Office Action Summary

09/743,726

GAMBALE ET AL.

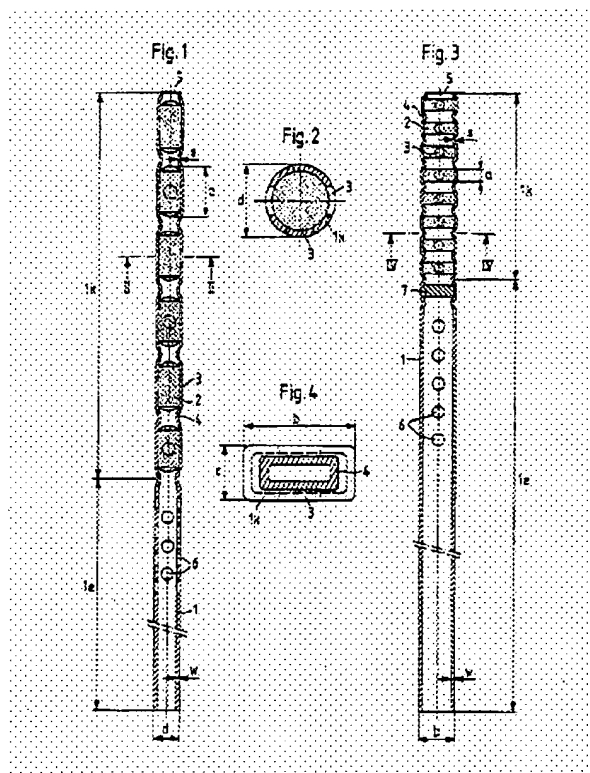
Claim 1 is rejected under 35 U.S.C. 102(b) as being anticipated by Reed, U.S. Patent No. 3,443,561. The cited patent discloses a pellet containing a therapeutic agent; a flexible, implantable body having a hollow interior configured to receive and retain the pellet within the interior after the body has been implanted within tissue.

Figures 1-3 show a pellet containing a therapeutic agent; a flexible, implantable body having a hollow interior configured to receive and retain the pellet within the interior after the body has been implanted within tissue.

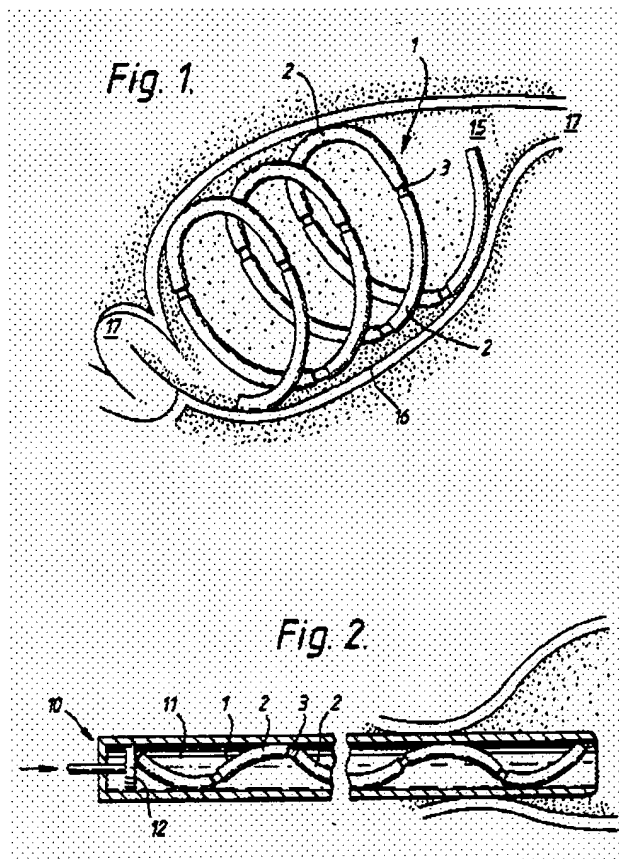
Claim 5 is rejected under 35 U.S.C. 102(b) as being anticipated by Billeter, et al., U.S. Patent No. 4,731,054. The cited patent discloses a pellet containing a therapeutic agent; a flexible and implantable body defining an interior sized to accept the pellet and having proximal and distal ends; wherein, the proximal end is sized to accept the pellet and the body further having at least one opening sized to permit bodily fluid to enter the interior but sized to prevent the pellet from exiting the interior (see figures 1-4 below).

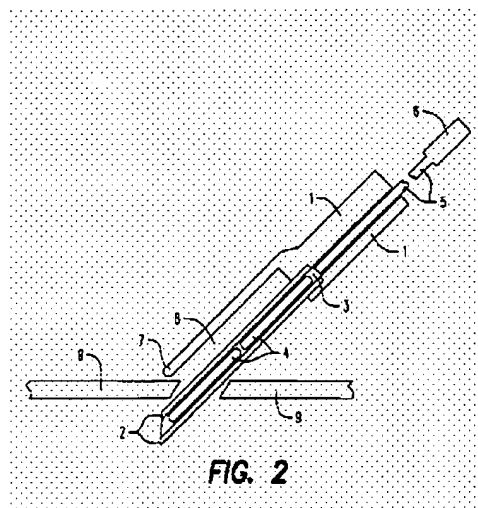
Claims 2, 6-8, and 10 are rejected under 35 U.S.C. 103(a) as being unpatentable over Billeter, et al., U.S. Patent No. 4,731,054 in view of Pryor, et al., U.S. Patent No. 5,062,829 and Gast, et al., U.S. Patent No. 5,984,890. The Billeter, et al. Patent does not disclose an implantable body comprising a helical spring and/or an obturator/insertion device combination.

In figures 1 and 2, Pryor, et al., shows an agent delivery system comprising a helical spring in combination with an insertion device. Moreover, it is the examiner's opinion, that it is well known in the art to use obturators with cutting edges to cut skin surfaces in order to facilitate the insertion of delivery systems into the body.

In order to support the above assertion, Gast, et al., shows in figure 2 an insertion/obturator device for the insertion/placement of solid materials into the body. Based on the teachings of Pryor, et al., and Gast, et al., for a person of ordinary skill in the art, it would have been considered obvious to design a delivery device with the shape of helical coil and capable of being inserted into the body using an insertion/obturator device. Accordingly, such enhancements would have been considered obvious design alternatives.
